Assessment of Dam Safety Coal Combustion Surface Impoundments (Task 3) Draft Report

Big Rivers Electric
Cooperative

Coleman Generating
Station

Hawesville, Kentucky

ACTIVE ASH POND A DIKE SECTION

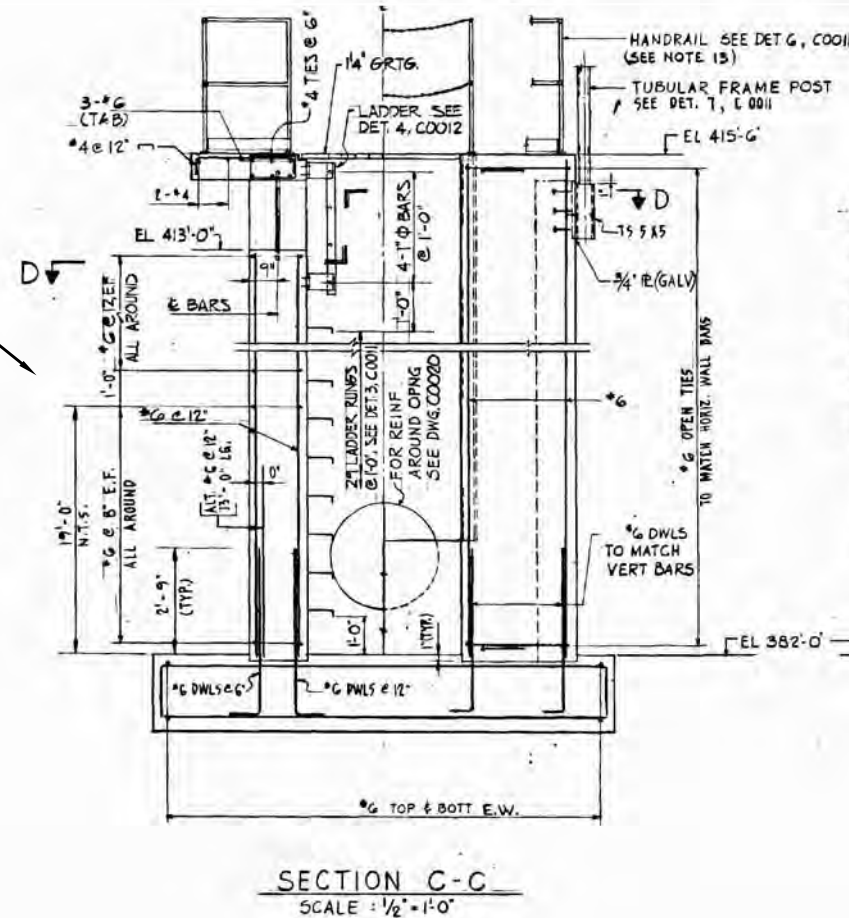
The original outlet structure, referred to in the design drawings as a drawdown structure, is an approximately 8-foot by 10-foot reinforced concrete spillway riser approximately 33.5 feet in height, located at the east end of the south dike. It is configured to utilize stop logs to control the pond elevation and releases water via a 36 inch diameter reinforced concrete pipe. This pipe has an outfall at the Ohio River. Presently, this spillway is inactive (Photo 20). At the time of the site visit, the pond level was approximately 3.5 below the top of the riser. Based upon the design plans that show a top elevation at 415.5, the pond surface was stable at approximately elevation 412.

The emergency spillway is located near the north end of the east dike (Photo 3). It is approximately 50 feet wide at the crest, with an invert set 1 foot below the crest at elevation 414. This spillway area was generally clear of any fouling debris or vegetation at the dike crest. Based upon a pond elevation at 412, there was about 2 feet of freeboard at the spillway. Very little difference between the dike crest elevation and spillway crest elevation was discernable in the field, despite the fact that plans note that there should be a 1 foot difference in the elevations.

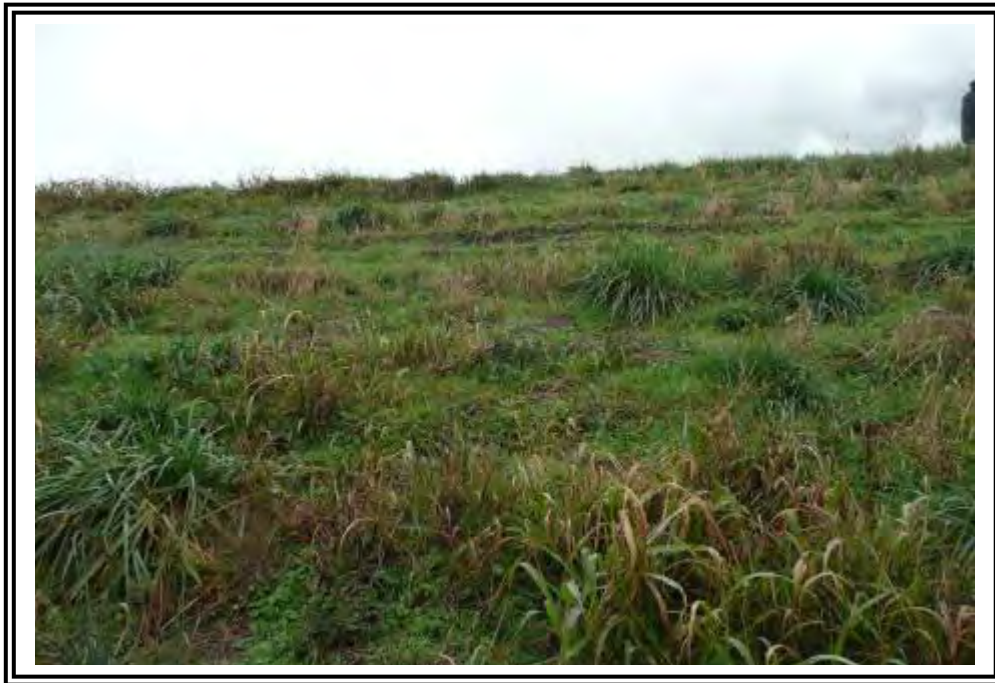
Inboard slope areas of the impoundment were generally rock or ash covered (Photos 4, 9, 13, 14, and 17). As a result of grading activities, looser materials had been pushed out on these slopes, making them susceptible to erosion rills in locations where surface runoff has become concentrated (Photos 10 and 18). These areas were also susceptible to beaching erosion, particularly in the western portion of pond. Available freeboard appears to be on the order 1.5 to

North dike inboard slope. Note beaching erosion and erosion rills.

Close up of slight beaching on inboard slope of north dike.
